UNITED STATES PATENT AND TRADEMARK OFFICE

APPLICATION NO.	FILING DATE	FIRST NAMED INVENTOR	ATTORNEY DOCKET NO.	CONFIRMATION NO.
09/897,779	06/29/2001	Zine Eddine Boutaghou	1734.001US1	9826

Office Action Summary

Addendum A

Fig. 2a

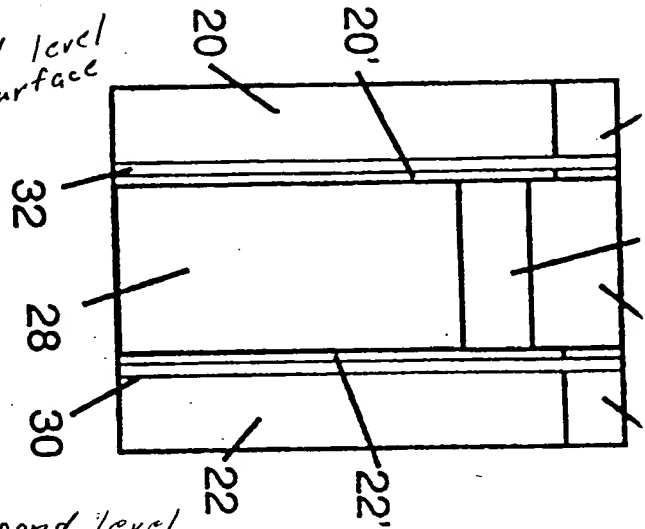
See Figs.2a,2c and 5d. Note, to the extent claimed and understood, the first, second and third level surfaces, and related structures, are as shown in Addendum A and read on and performs to the same degree as claimed.

third level surface

second level surface

first divider

first level surface

Fig. 2b
First Rail

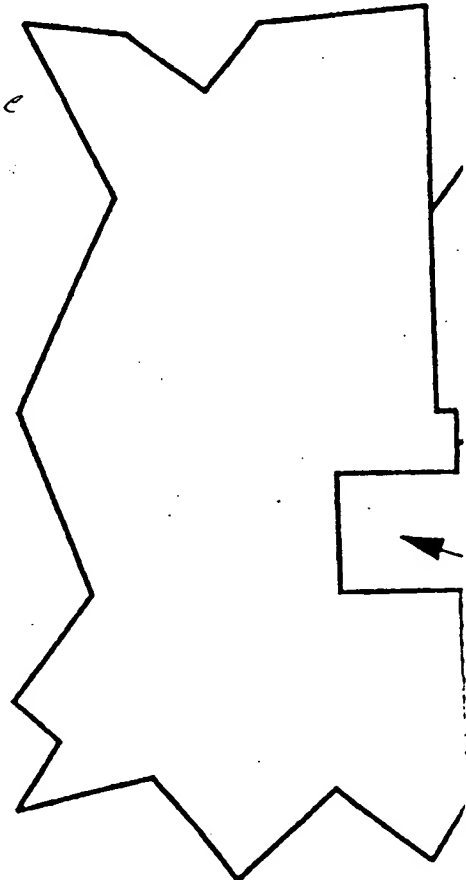
Re Cls.8-9: the first and second level surfaces have an inherent slope to them as shown in the Addendum A.

slope

Fig. 2c

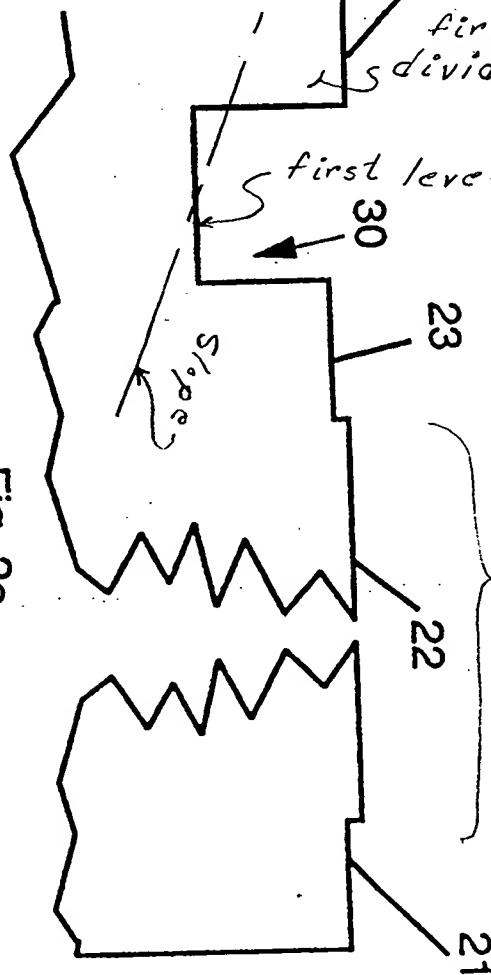
second divider
